# Rezoning Transportation Analysis

Petition Number: 2026-020

Date	Description
4-23-26	First Review (NK)

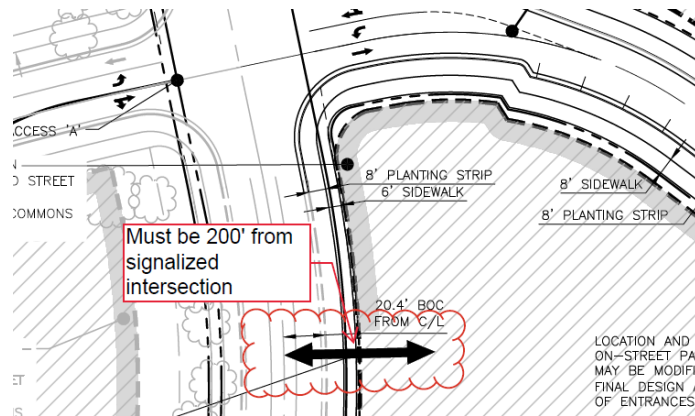
### 2. Revise site plan and conditional note(s) to commit to placing access at least 200' from signalized intersection.
